## TEXT OF FINAL RULE

**SECTION 1.** PSC 114.001 (3) is amended to read:

(3) AVAILABILITY OF STATE ELECTRICAL CODE. The commission has adopted the ~~2012~~ 2017 edition of the National Electrical Safety Code (~~NESC-2012~~ NESC-2017) with certain deletions, changes and additions which are found in Volume 1, Wisconsin State Electrical Code. Copies of the NESC may be purchased from the Institute of Electrical and Electronics Engineers, Inc., IEEE Service Center, 445 Hoes Lane, P.O. Box 1331, Piscataway, NJ 08855-1331 (telephone 1-800-678-IEEE) or the American National Standards Institute, 1430 Broadway, New York, NY 10018 (telephone 212/642-4900). Copies of the NESC may be ordered online at <http://standards.ieee.org/nesc>. Copies of Volume 1, Wisconsin State Electrical Code, may be ordered from the Wisconsin Department of Administration, Document Sales, 202 S. Thornton Avenue, Madison, WI 53702 (telephone 608/266-3358). Unofficial copies of the rules can be obtained online at [http://docs.legis.wi.gov/code/admin\\_code/psc/114/](http://docs.legis.wi.gov/code/admin_code/psc/114/).

Figure PSC 114-317B1.

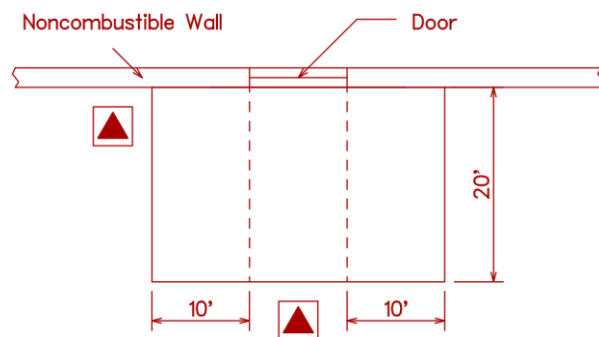
1. Padmounted oil-insulated transformers shall not be located within a zone extending 6.1 m (20 ft) outward and 3.0 m (10 ft) to either side of a building door. See Figure PSC 114-317B1.

Figure PSC 114-317B2.

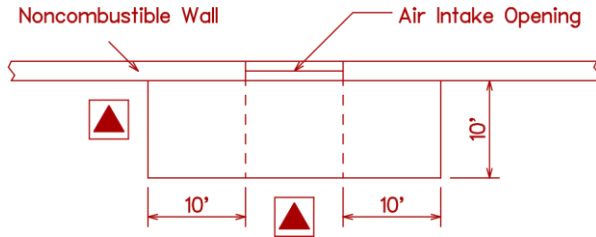
2. Padmounted oil-insulated transformers shall not be located within a zone extending 3.0 m (10 ft) outward and 3.0 m (10 ft) to either side of an air intake opening. Such transformers may be

located within said zone beneath an air intake opening provided there is not less than 7.6 m (25 ft) diagonal separation between the transformer and said opening. See Figure PSC 114-317B2.

Figure PSC 114-317B3a.

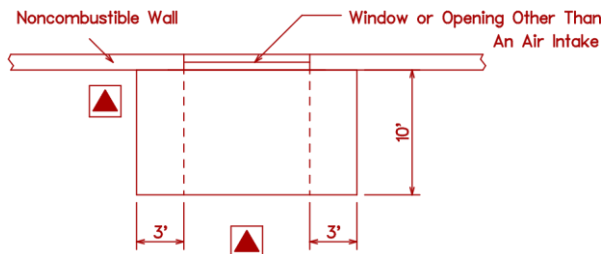
3.a. Padmounted oil-insulated transformers shall not be located within a zone extending 3.0 m (10 ft) outward and 0.9 m (3 ft) to either side of a building window or opening other than an air intake. See Figure PSC 114-317B3a.

Exception: This does not apply to a glass block or fire window meeting the requirements of the Wisconsin Commercial Building Code (Fire Window IBC Chapter 7, Section 714.3).

Figure PSC 114-317 B3b.

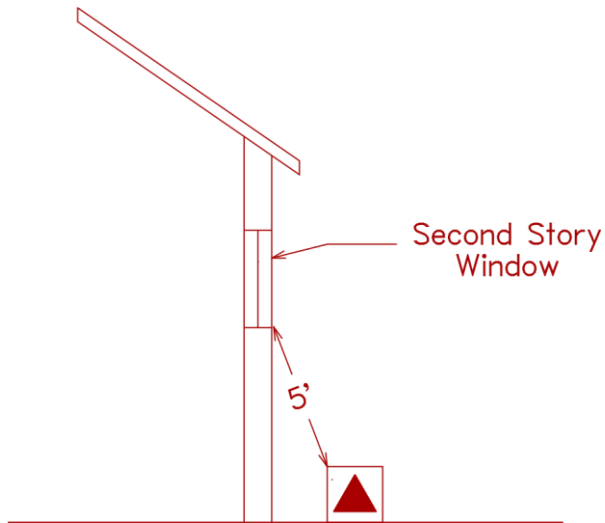
3.b. For second story windows, the transformer shall not be located less than 1.5 m (5 ft) from any part of the window. See Figure PSC 317B3b.

Exception: This does not apply to a glass block or fire window meeting the requirements of the Wisconsin Commercial Building Code (Fire Window, IBC Chapter 7, Section 714.3).

Figure PSC 114-317D1.

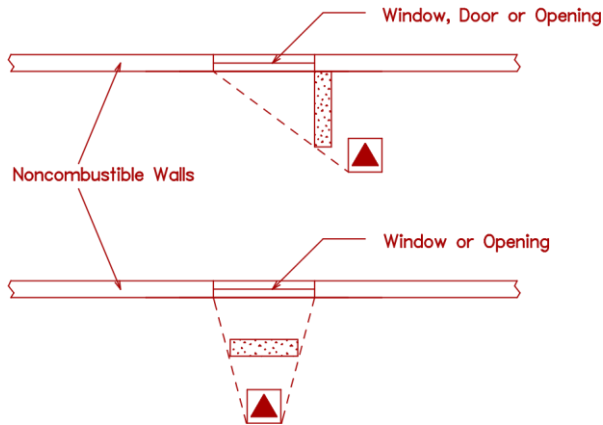
The barrier shall extend to a projection line from the corner of the padmounted transformer to the furthest corner of the window, door or opening in question. The height of the barrier shall be 0.3 m (1 ft) above the top of the padmounted transformer. See Figure PSC 114-317D1.

Figure PSC 114-317D2.

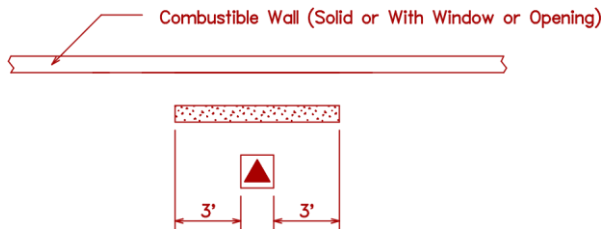
The barrier shall extend 0.9 m (3 ft) beyond each side of the padmounted transformer. The height of the barrier shall be 0.3 m (1 ft) above the top of the transformer. See Figure PSC 114-317D2.

Figure PSC 114-317E1

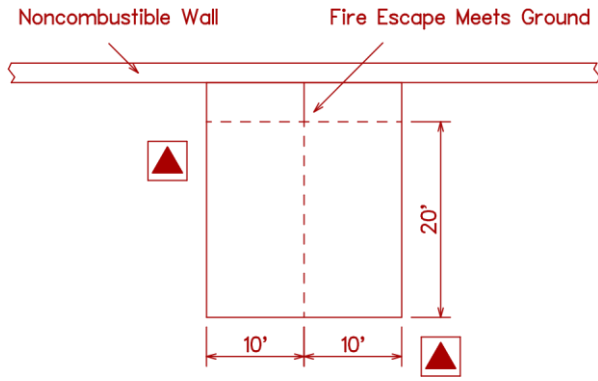
1. Padmounted oil-insulated transformers shall not be located within a zone extending 6.1 m (20 ft) outward and 3 m (10 ft) to either side of the point where a fire escape meets the ground. See Figure PSC 114-317E1.

Figure PSC 114-317E2

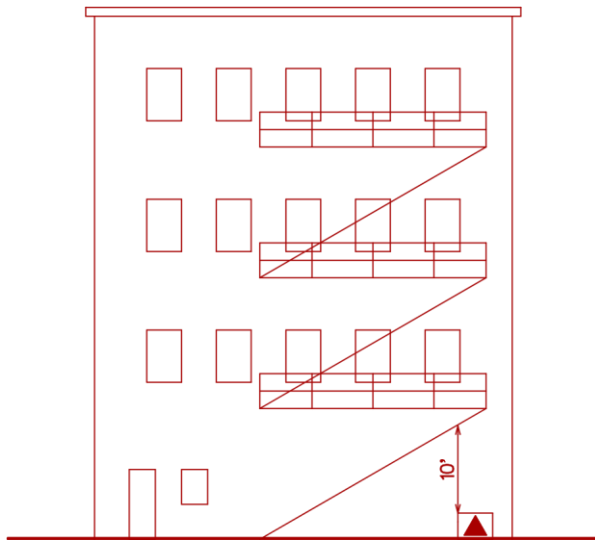
2. Padmounted oil-insulated transformers located beneath fire escapes shall have a vertical clearance of not less than 3 m (10 ft) from the top of the transformer to the bottom of the fire escape. See Figure PSC 114-317E2.
